AMENDMENT TO FACILITY OPERATING LICENSE

Amendment No. 10
License No. DPR-29

CHANGE NO. 19 TO TECHNICAL SPECIFICATIONS (APPENDIX A)

SAFETY EVALUATION BY THE DIRECTORATE OF LICENSING
SUPPORTING AMENDMENT NO. 10 TO LICENSE NO. DPR-29
(CHANGE NO. 19 TO APPENDIX A TECHNICAL SPECIFICATIONS)

FIGURE 3.5.1 MAXIMUM ALLOWABLE PLANAR LHGR APPLICABLE TO QUAD-CITIES INITIAL AND RELOAD FUEL

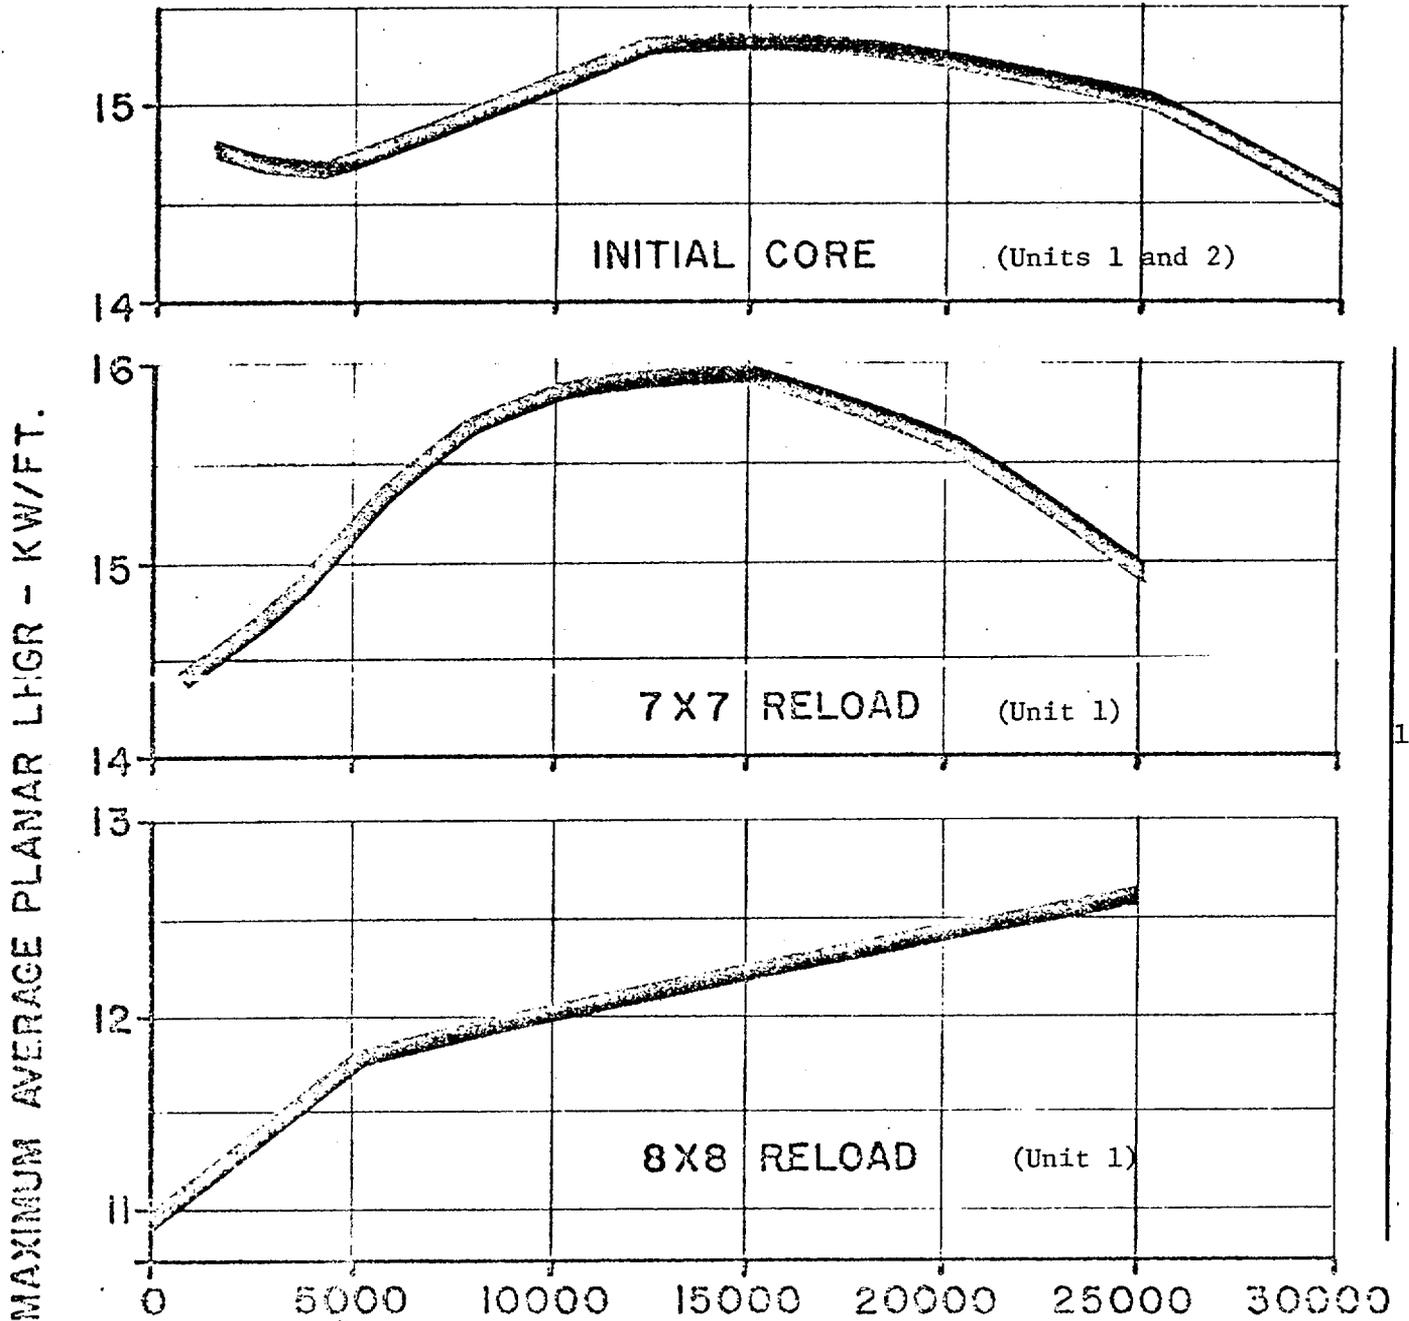
19 I. Average Planar LHGR

During steady state power operation, the average linear heat generation rate (LHGR) of all the rods in any fuel assembly, as a function of average planar exposure, at any axial location, shall not exceed the maximum average planar LHGR shown in Figure 3.5.1.

The maximum average planar LHGRs shown in Figure 3.5.1 are based on calculations employing the models described in Reference 1 as modified by Reference 2, and authorized in Reference 3.

Average planar and local LHGR is a function of the fuel type and is related to fuel densification. Since a new fuel type (the 8 x 8) and new 7 x 7 fuel is being added to the core, new limitations must be incorporated in the Technical Specifications. In addition, the limits for the 7 x 7 fuel can utilize the revised fuel densification model approved by the staff in December 1973⁽³⁾. The use of the revised densification model and the resultant change in average planar and local LHGR limits was reviewed for Quad-Cities Unit 1 and approved by Change 16 to DPR-29 dated May 14, 1974. That evaluation concluded that the use of the new model has essentially no effect on normal operation and improves the margins to pressure and minimum critical heat flux ratio limits for overpressurization and core flow reduction transients. The staff also concluded that the limitations of the average linear heat generation rate of all rods in any fuel assembly, calculated by use of the new fuel densification model, assure that the calculated peak clad temperatures in the event of a loss-of-coolant accident will not exceed 2300°F. The staff report on 8 x 8 fuel⁽¹⁾ notes that the fuel densification model is equally applicable to the 8 x 8 fuel. Therefore, the proposed technical specifications for average planar and linear LHGRs, calculated by use of the approved fuel densification model, are acceptable.
